**TOWN OF BLIND RIVER
REQUEST FOR TENDER
NEW BLIND RIVER WATER TREATMENT PLANT INTAKE AND LOW LIFT PUMPING STATION
CONTRACT NO. PS-2026-01**

**ADDENDUM #8
March 4th, 2026**

DRAWING TITLE:
**PLAN & PROFILE
 9+591.2 TO 9+900**

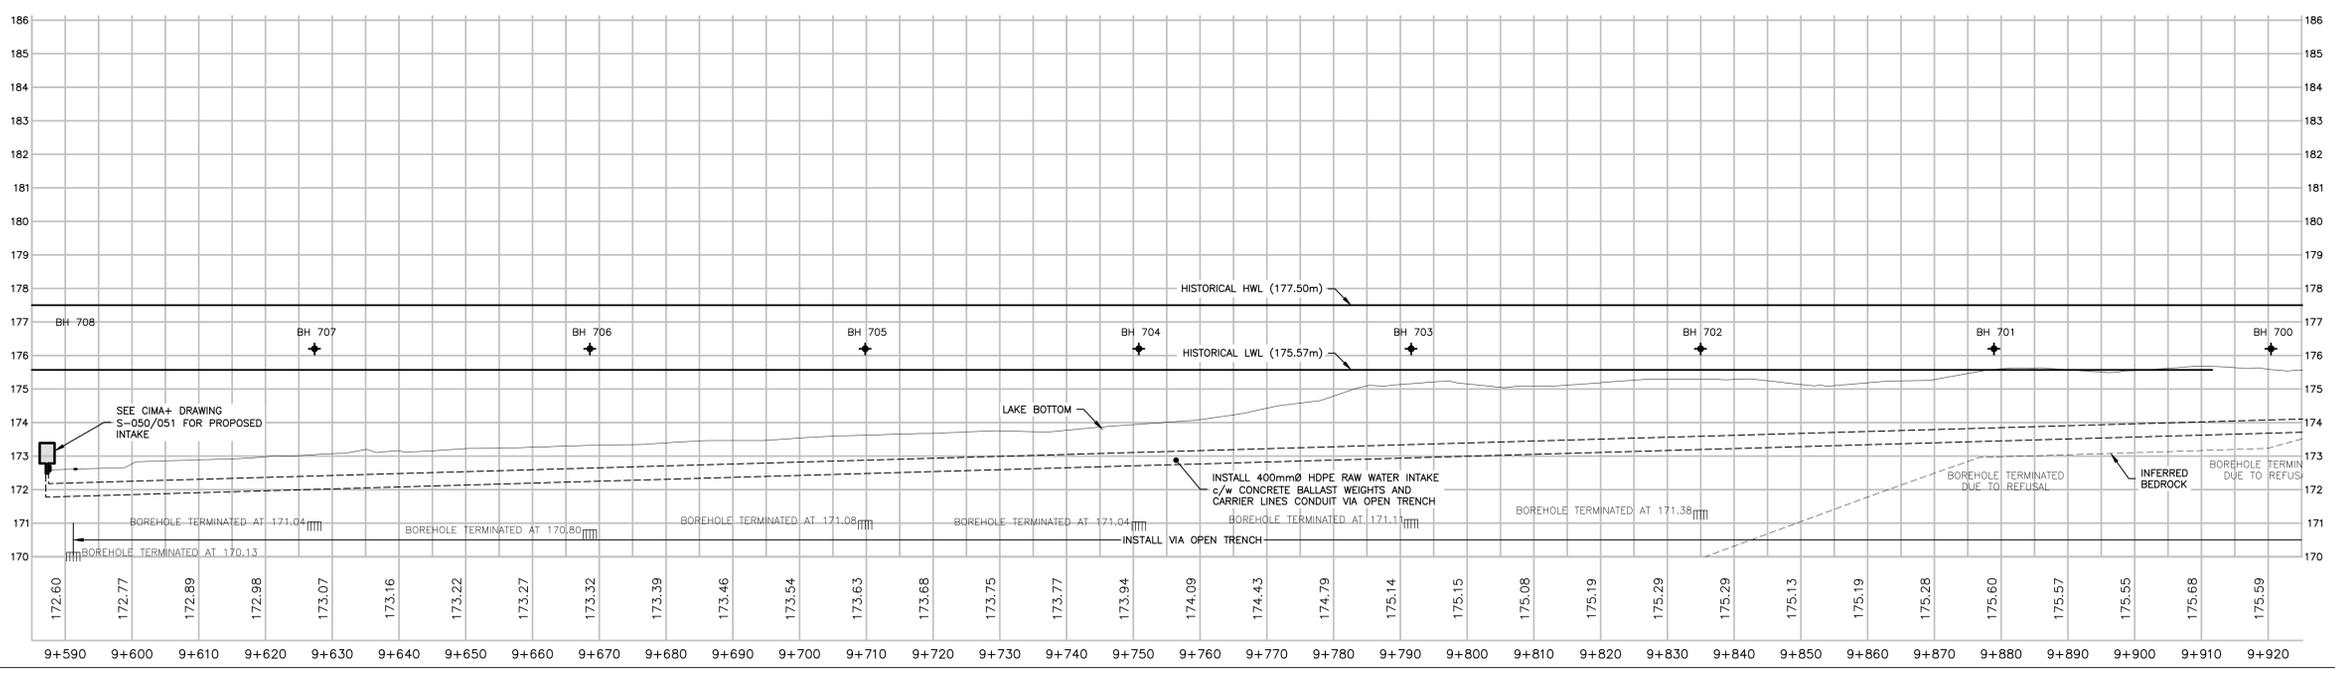
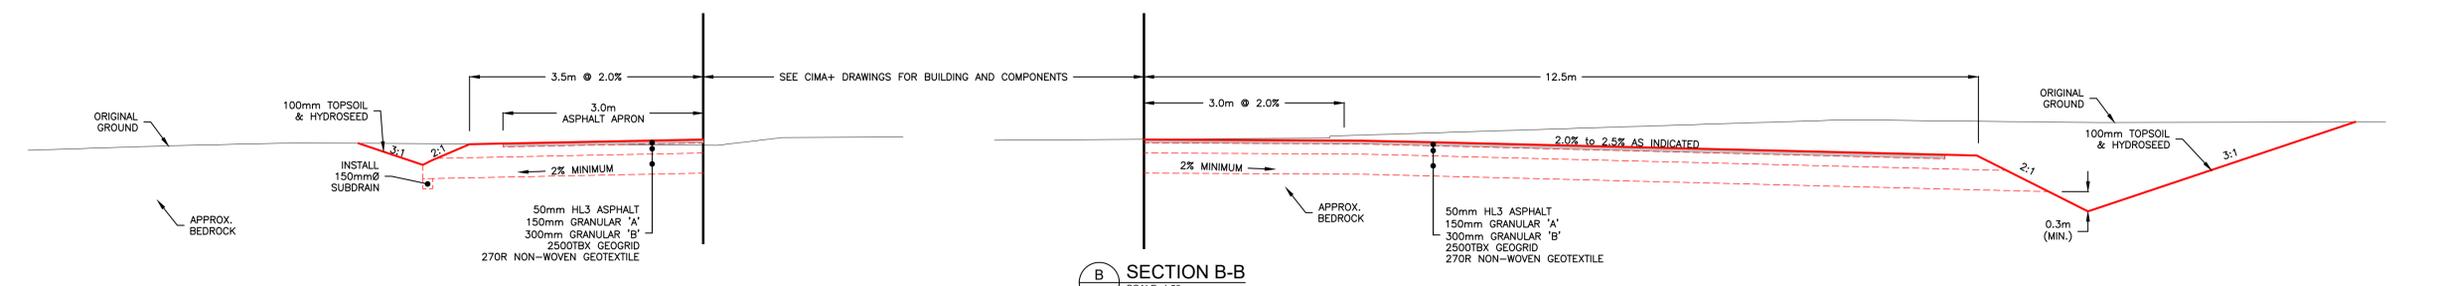
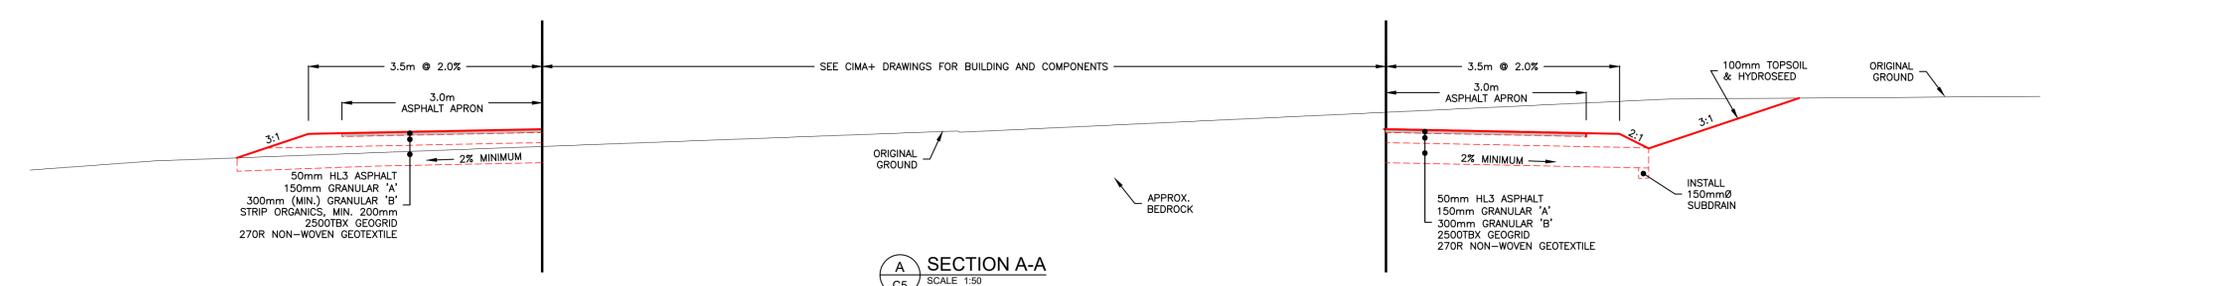
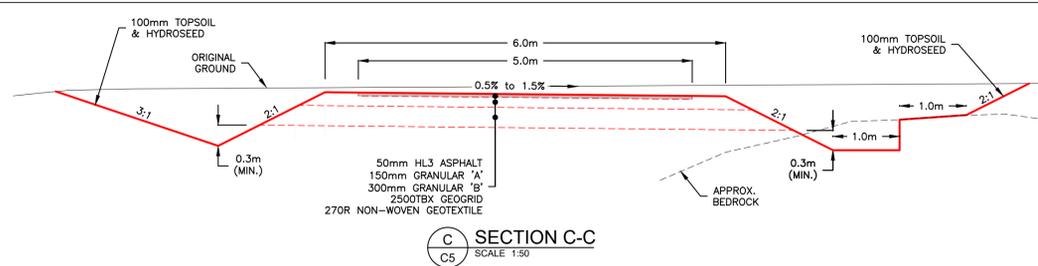
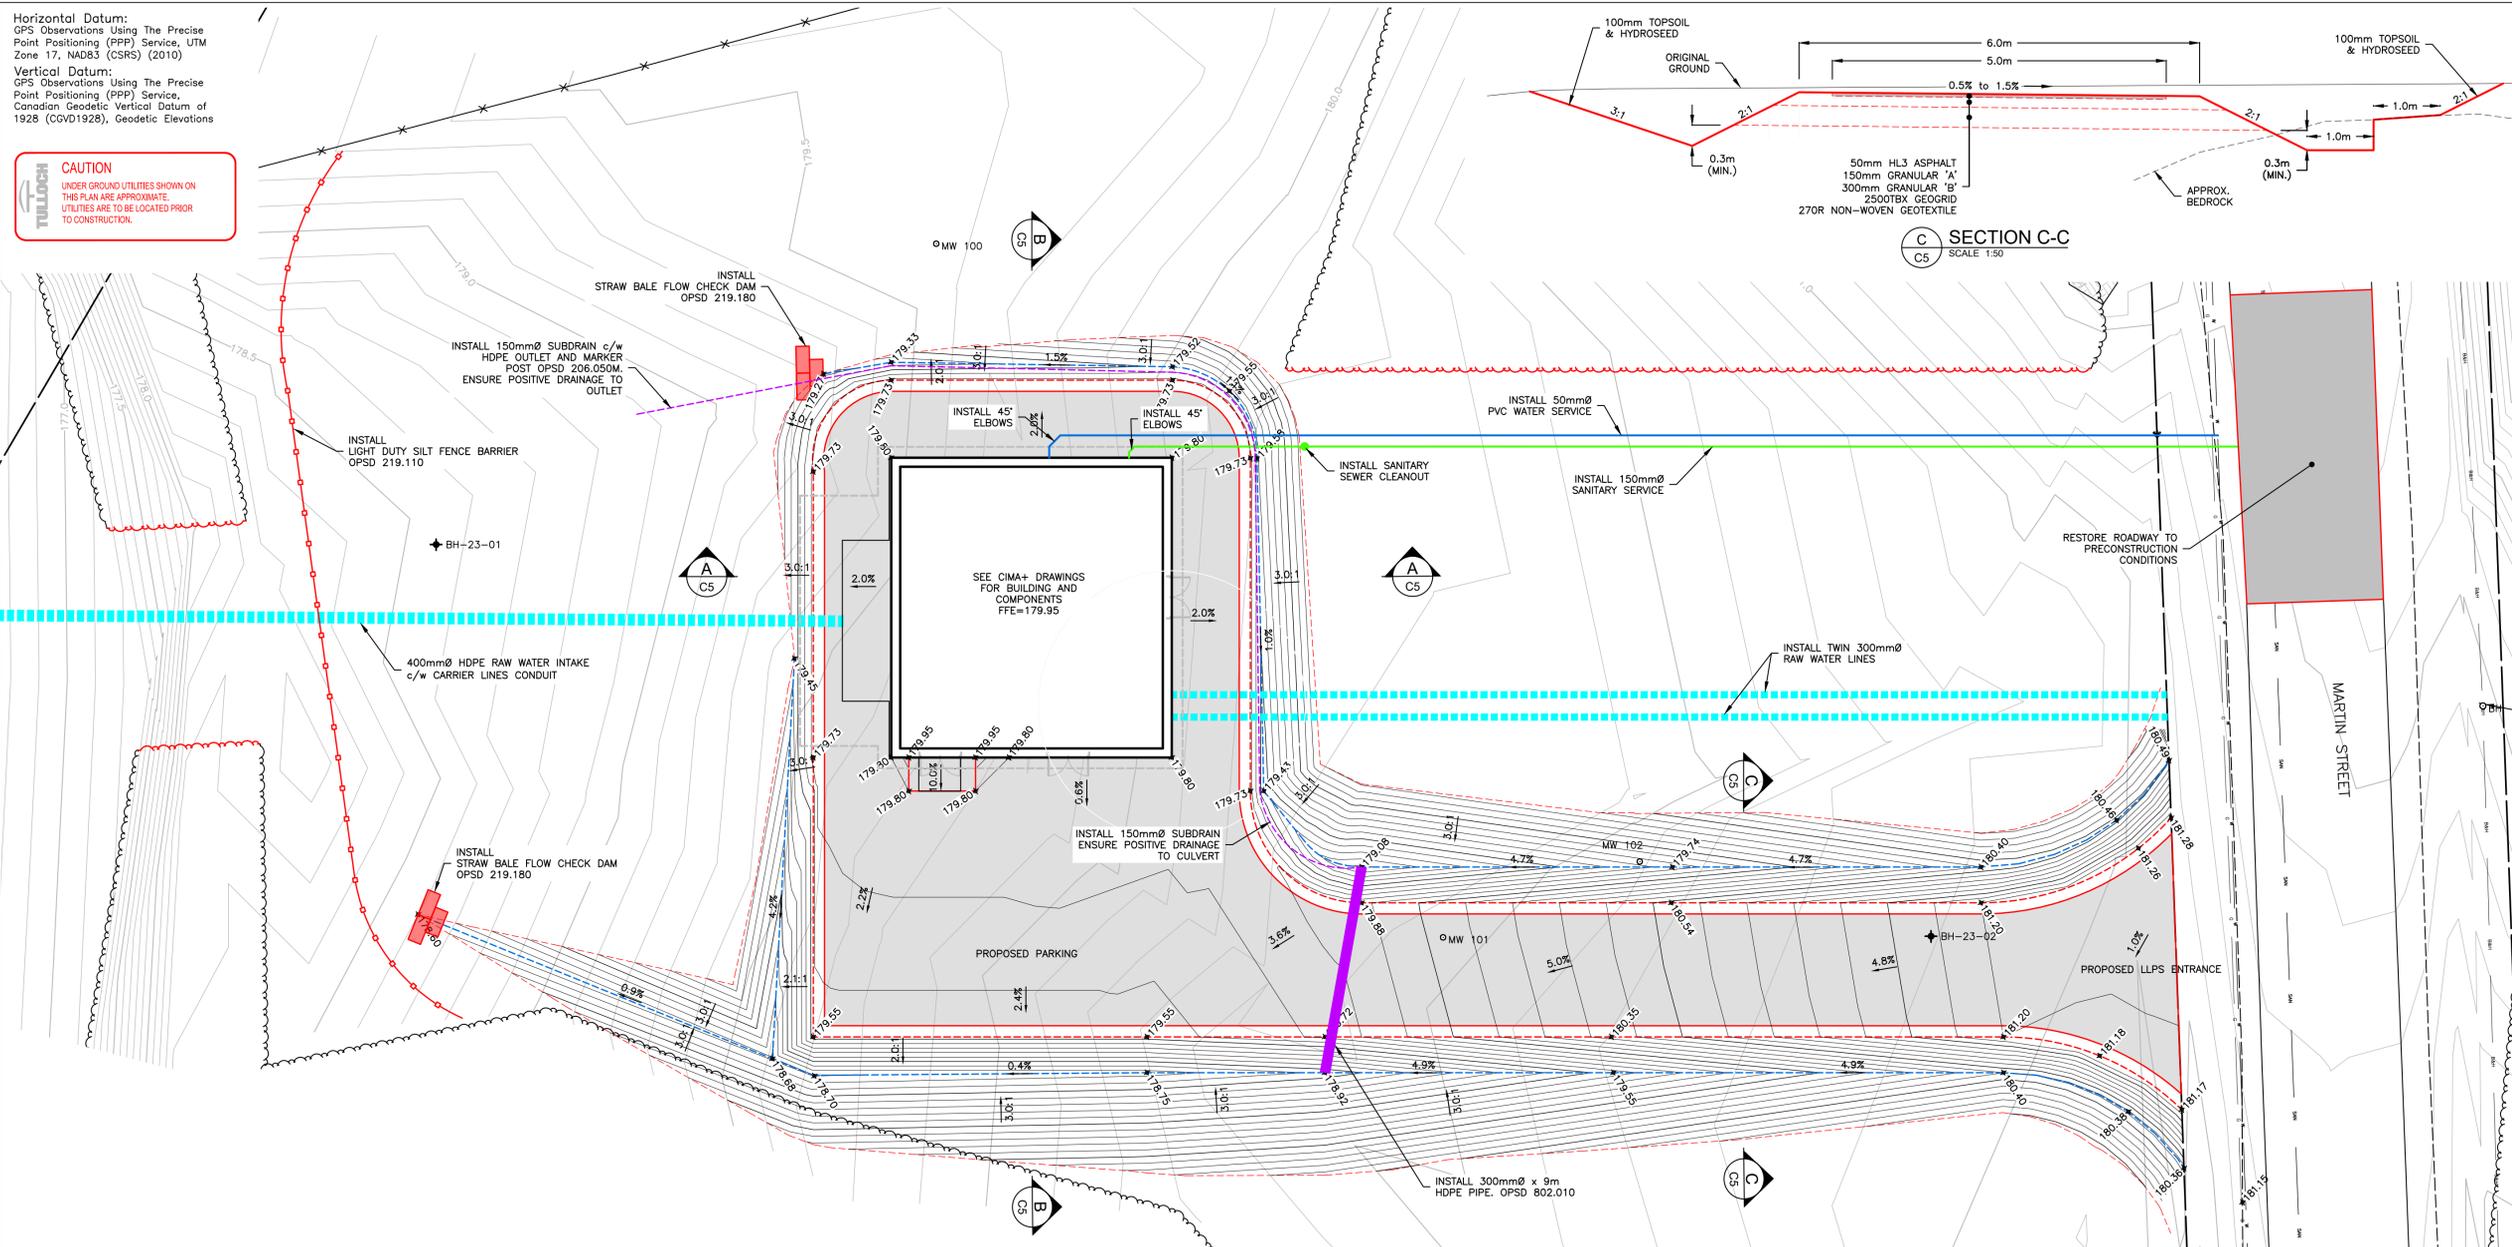
Please note, the intake and carrier lines installation has been changed from Horizontal Directional Drilling (HDD) to Conventional Open Trenching. All references to HDD shall be removed from the tender and replaced with Open Trenching, per OPSS.MUNI 441. The intake and carrier lines shall be installed on concrete ballast blocks to the lines and grades indicated and the lakebed backfilled. Attached are updated design drawings C1 thru C6.

Q:19 Please clarify the bedrock elevations. There are discrepancies between the geotechnical and hydrogeological reports.

A:19 The rock elevations listed in each report are accurate based on field conditions encountered. The inferred bedrock surface identified on the plans has been interpolated based on these boreholes and has been updated on the revised plans attached.
